**RE: 1 CARRINGTON STREET, SYDNEY**  
**TRANSPORT ASSESSMENT REVIEW FOR SECTION 96 APPLICATION**

Transport for NSW (TfNSW) has requested additional information regarding the Section 96 application lodged for the approved development at 1 Carrington Street, Sydney.

Figure 1: Streetscape Public Domain Concept Plan

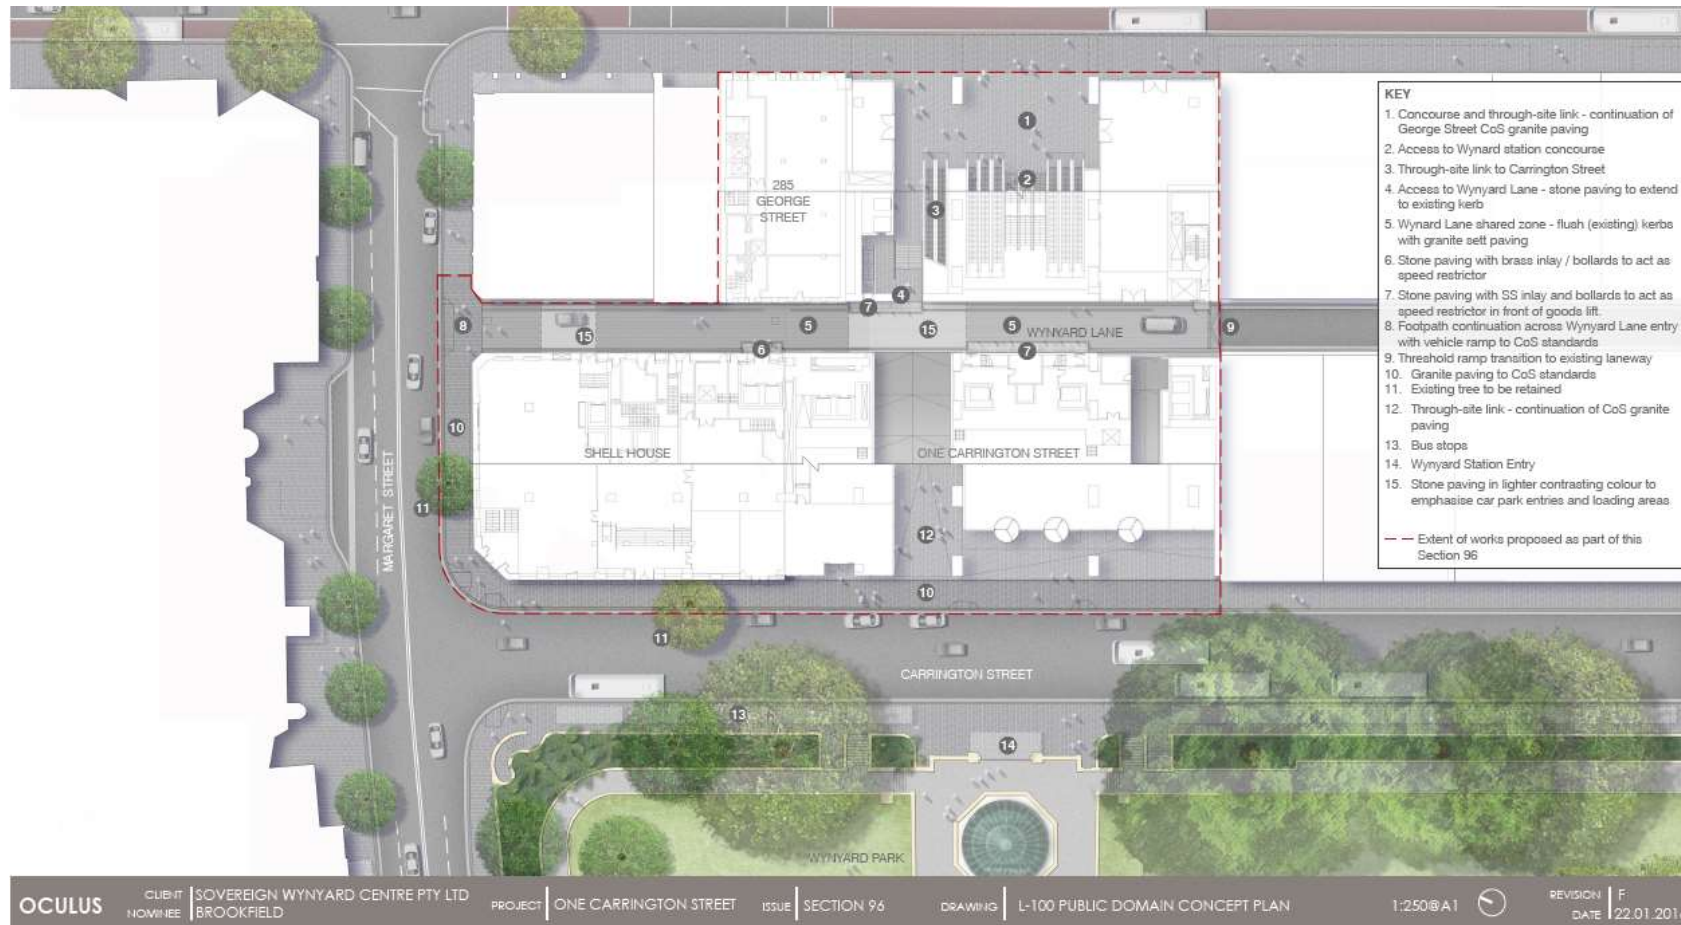
- "Proposed Stone Paving with Brass Inlay/Bollards
  - The Public Domain Concept Plan (PDCP) prepared as part of the modification proposal includes stone paving with brass inlay/bollards to act as a speed restrictor. The proposed arrangement is not supported by TfNSW due to the following reasons:

- The proposed arrangement would guide vehicles to travel along the eastern side of Wynyard Lane. As a result of this, pedestrians entering Wynyard Lane opposite to the applicant's car park access from the east would step into the path of oncoming vehicles. Therefore, there is a potential conflict between pedestrians entering Wynyard Lane and the vehicles travelling along Wynyard Lane.

- The proposed stone paving with brass inlay/bollards area located south of Margaret Street on Wynyard Lane may have the potential to restrict the turning path of the vehicles accessing the loading bay for the proposed development at 275-281 George Street.

- Based on the above, TfNSW requests that the applicant demonstrates the proposed stone paving with brass inlay/bollards along Wynyard Lane would not have impact on the proposed development at 275-281 George Street and the pedestrian safety along Wynyard Lane."

The proposed Shared Zone design has been revised to provide a central trafficable lane width of 3.5m with 1.3m wide (approx.) brass inlay/bollard areas along both eastern and western sides of the laneway. This concept is shown plans prepared by Oculus, reproduced in 1 and 2.
